UNITED STATES PATENT AND TRADEMARK OFFICE

APPLICATION NO.	FILING DATE	FIRST NAMED INVENTOR	ATTORNEY DOCKET NO.	CONFIRMATION NO.
10/634,123	08/04/2003	Edmund Koon Tian Lua	2269-5709US (02-1462.00/U)	5763
24247	7590	10/20/2005	EXAMINER ANDUJAR, LEONARDO	
TRASK BRITT P.O. BOX 2550 SALT LAKE CITY, UT 84110			ART UNIT 2826	PAPER NUMBER

Office Action Summary	Application No. 10/634,123	Applicant(s) LUA ET AL.	
	Examiner Leonardo Andújar	Art Unit 2826

DETAILED ACTION

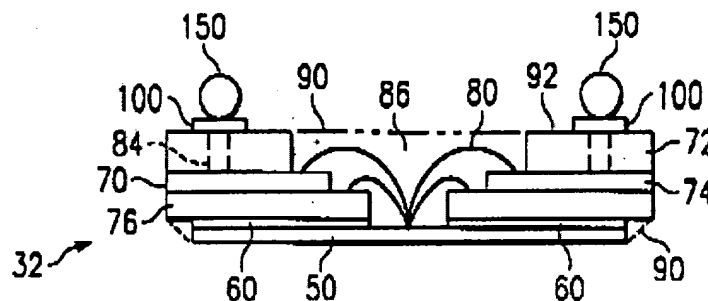
6. Regarding claim 26, Yew (e.g. figs. 2 & 3)) shows a semiconductor assembly comprising: at least one semiconductor die having a plurality of bond pads 120 formed

on active surface thereof; at least one anisotropically conductive layer 70 comprising a plurality of laterally isolated conductive elements 84 disposed in a dielectric material 72 (i.e. FR-4) and having an upper end exposed therethrough attached to the active surface by the adhesive layer 60; a plurality of conductive bumps 150 on the at least one anisotropically conductive layer with each of the plurality of conductive bumps in contact with at least one conductive element of the plurality; and wire bonds 80 between the bond pads and the conductive bumps.

Fig.3

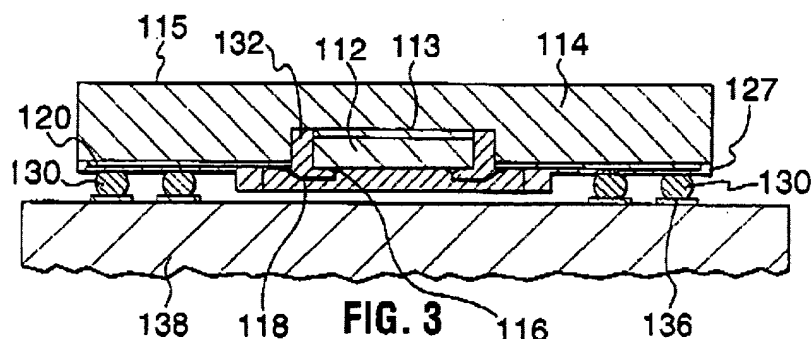
14. Regarding claim 31, Yews shows most aspect of the instant invention except for a conductive element comprising at least one of tungsten, aluminum, copper, silver, gold, and alloys thereof. Nevertheless, Sato (e.g. fig. 3) shows a structure analogous to the conductive layer 72 disclosed by Yews were the conductive element 20 is made of copper.

It would have been obvious to one of ordinary skill in the art at the time the invention was made to make the conductive element disclosed by Yew of copper as

suggested by Sato because copper has a high conductivity, is easily fabricated, and has an excellent corrosion resistance in natural environments.

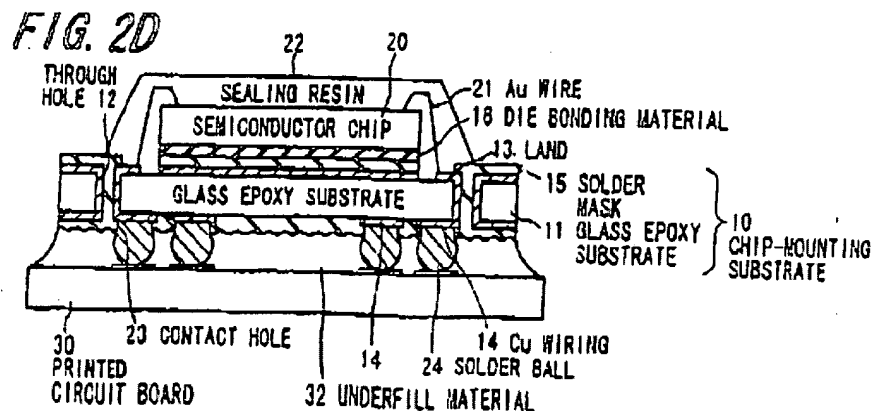
16. Regarding claim 33, Yew teaches most aspects of the instant invention including semiconductor substrate assembly attached to a substrate (col. 2/29-32). Yew does not disclose a substrate having a plurality of terminal pads on a surface thereof; and wire bonds extending between the plurality of conductive bumps and the plurality of terminal pads. Nevertheless, Marcantonio (e.g. fig. 3) teaches an analogous embodiment that includes a substrate 138 having a plurality of terminal pads 136 on a surface thereof, and bonds 118 extending between the plurality of conductive bumps and the plurality of terminal pads. This type of substrate serves a variety of functions. Foremost, it contains the wiring required to interconnect the components electrically, acts as the primary structure to supports those components and is also used to conduct away heat generated by the components.

It would have been obvious to one of ordinary skill in the art at the time the invention was made to include a substrate having a plurality of terminal pads on a

surface thereof in Yew's invention as suggested by Marcantonio to provide support, a interconnection medium and a heat transfer path. Note that in this combination the wire bonds are located between the plurality of conductive bumps and the plurality of terminal pads.
